Review Comments

Source Control Evaluation Report

Intrepid Marble and Granite

Report Dated April 11, 2023

Figure 1: Excerpt from the Final RM9W PDI Evaluation Report showing location of RM9W-C02 adjacent to OF-19

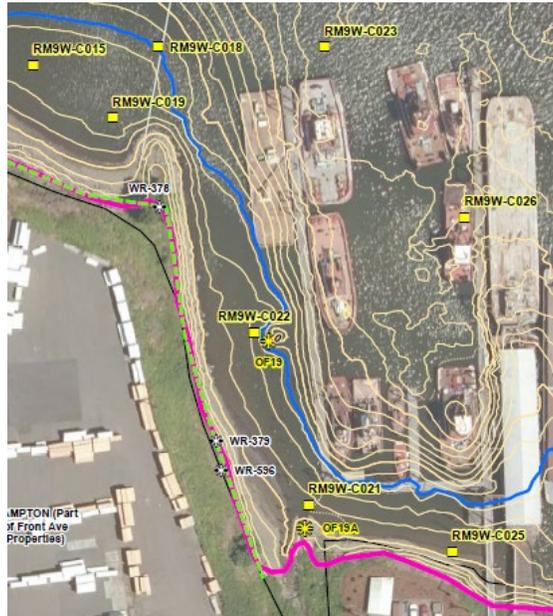
2. Due to new data showing dioxins closer to Outfall 19 (OF-19), EPA asks that the Site add dioxins/furans (D/Fs) as an analyte for stormwater sampling. Surface sampling was conducted sitewide within the Portland Harbor Superfund Site in 2018. The sample taken nearest to Outfall 19 did not show elevated D/Fs, however this sample location was approximately 200 feet away from OF-19 and on the other side of a floating dock, near RM9W-C023. During the 2021 Pre-Design Investigation sampling work in-water work, the RM9W Project Area collected a surface sediment sample at the mouth of OF-19 and stormwater solids sample from OF-19 that exceed Portland Harbor remedial action levels (RALs). The sediment location, RM9W-C022 is shown on the excerpt in Figure 1 (FMC 2022). The surface sediment concentration of PeCDD was 3.57 pg/g and the surface sediment concentration of TCDD was 1.03 pg/g which are above the respective RALs. The in-line sediment trap stormwater solids collected from location RM9W-AAP929 also exceeded the PeCDD RAL. The in-line sediment trap stormwater solids PeCDD concentrations ranged from 2.00 to 3.36 pg/g in November and June, 2021, respectively. While

there are multiple sources of material that may impact the concentrations of D/Fs in surface sediment, EPA is looking to use empirical data to confirm that the Site is not a contributor of D/Fs to Outfall 19.
